Appendix 3.13 - revised Level 0
Plan (ref: PL_102 Rev D) and
Courtyard elevations (5 Oct 2020)

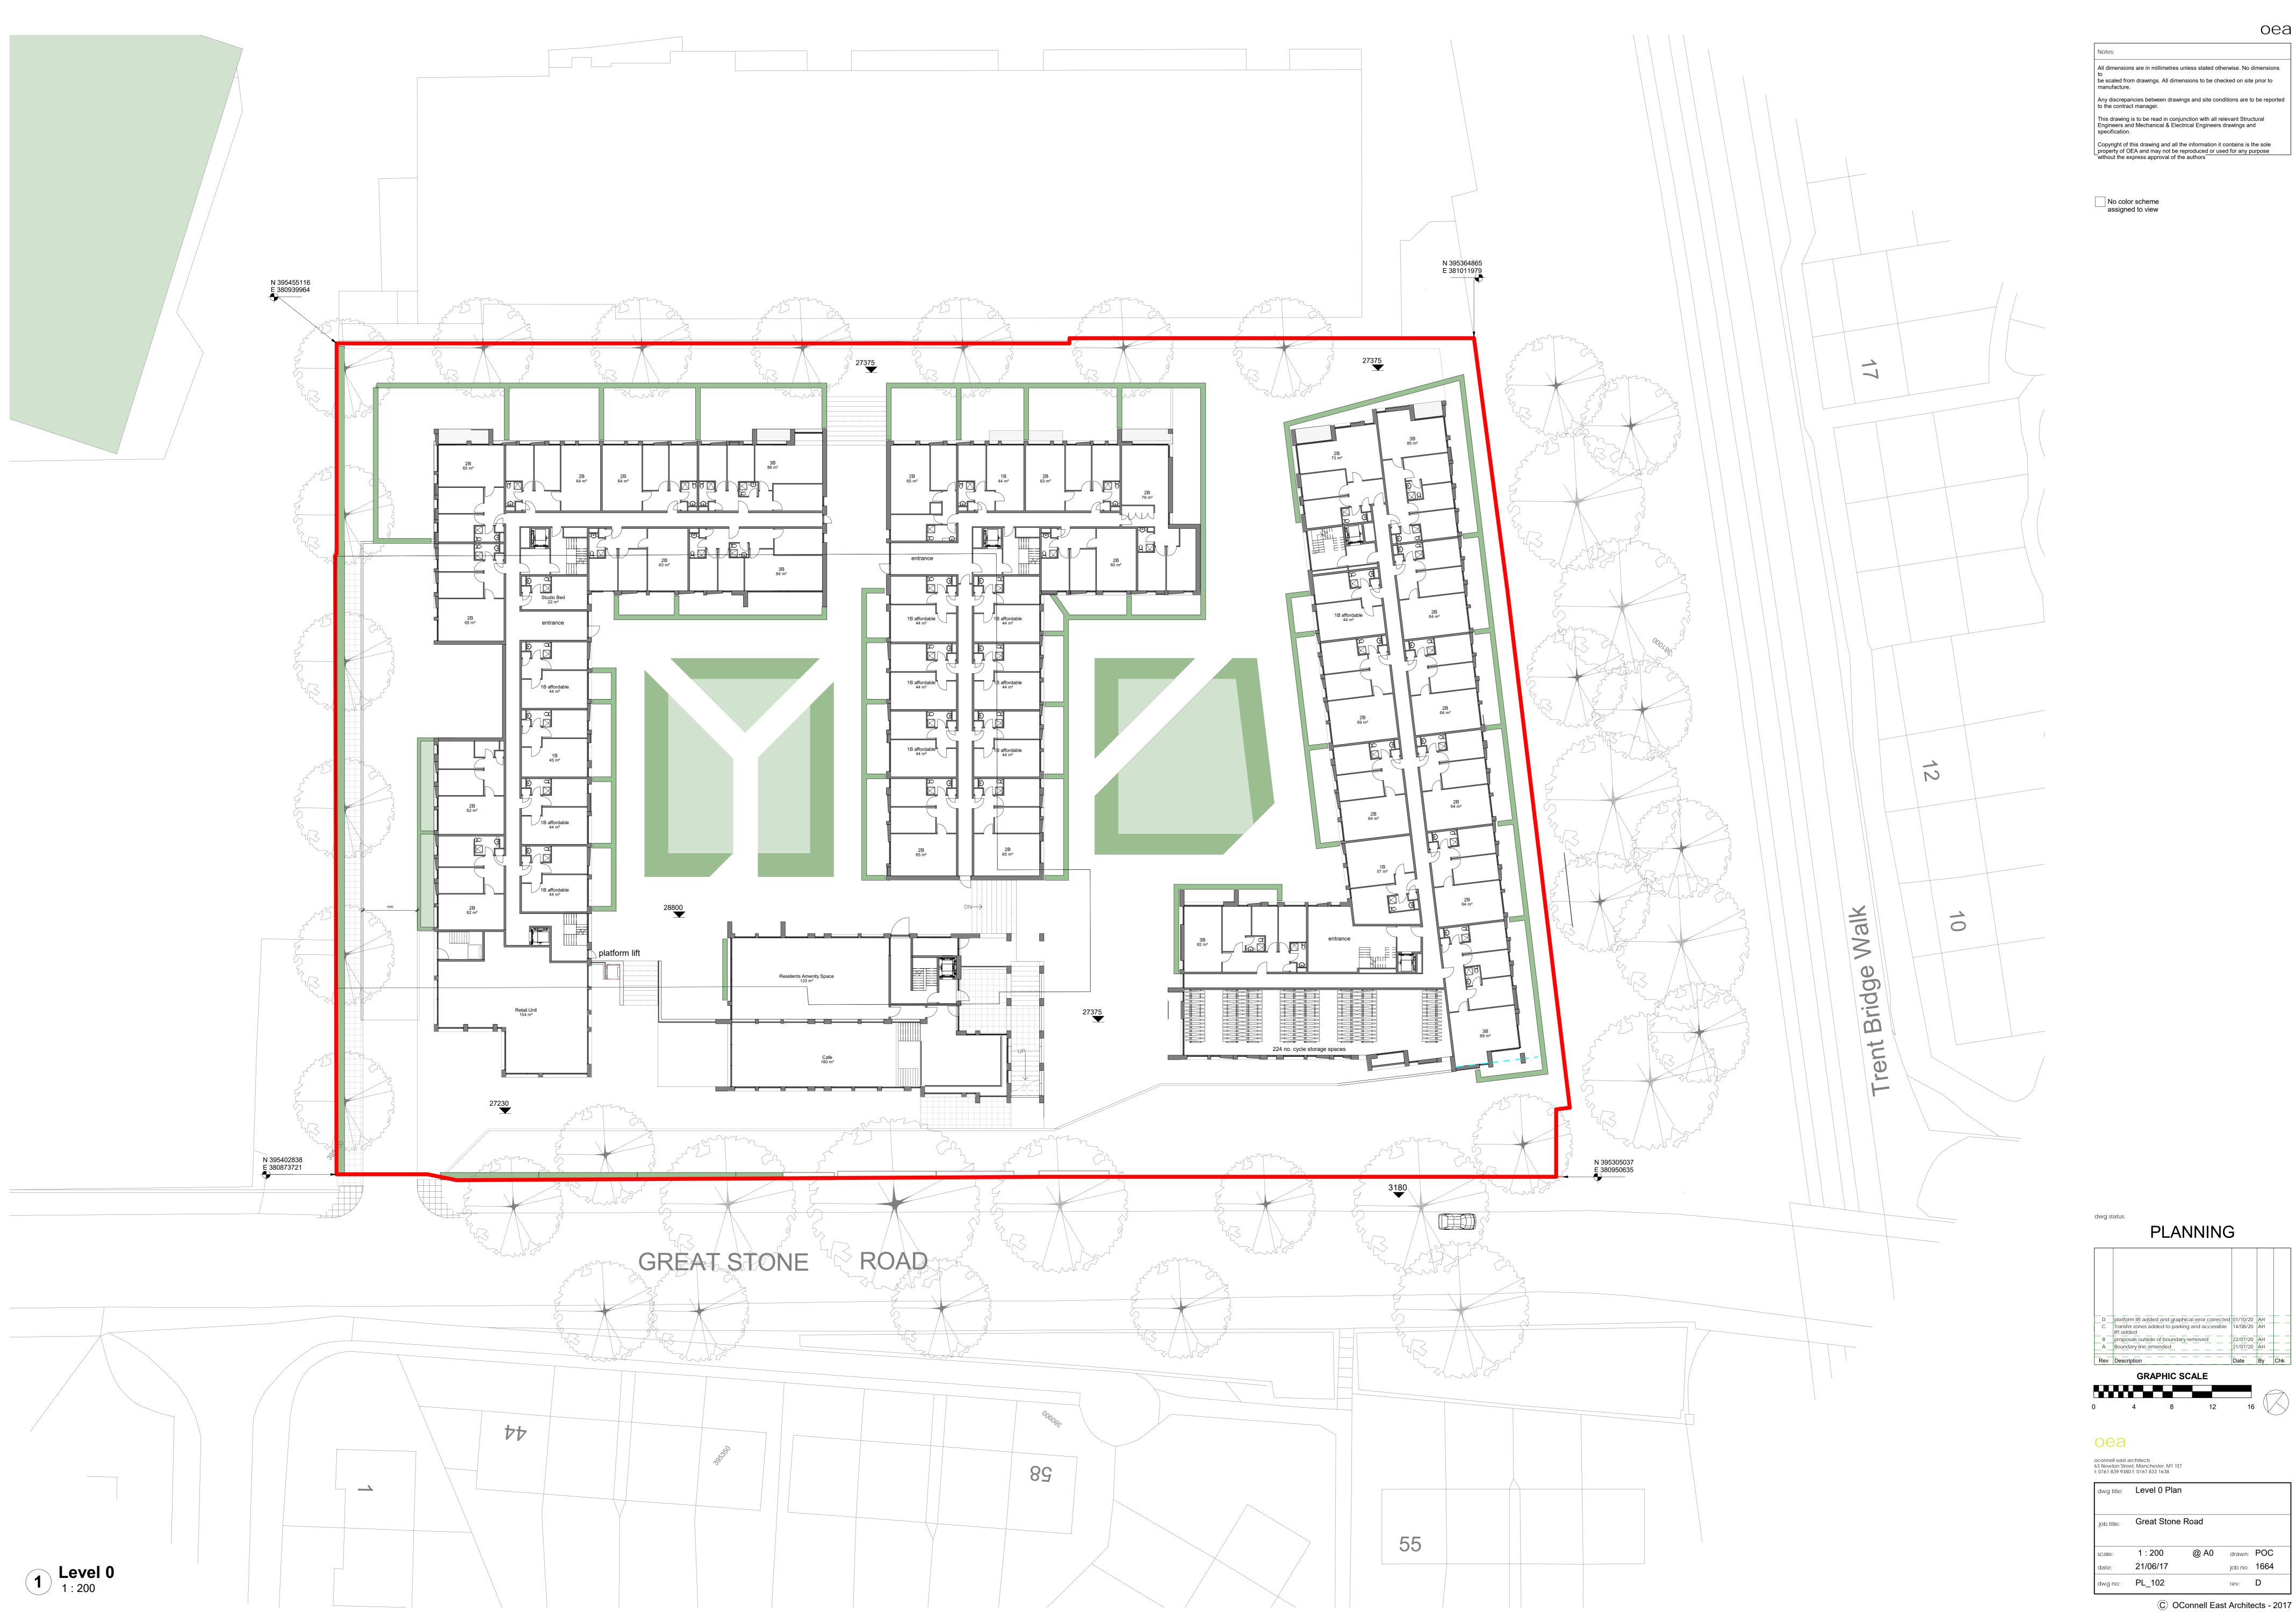
D platform lift added and graphical error corrected 01/10/20 AH
C Transfer zones added to parking and accessible lift added
B proposals outside of boundary removed 22/07/20 AH
A Boundary line amended 21/07/20 AH
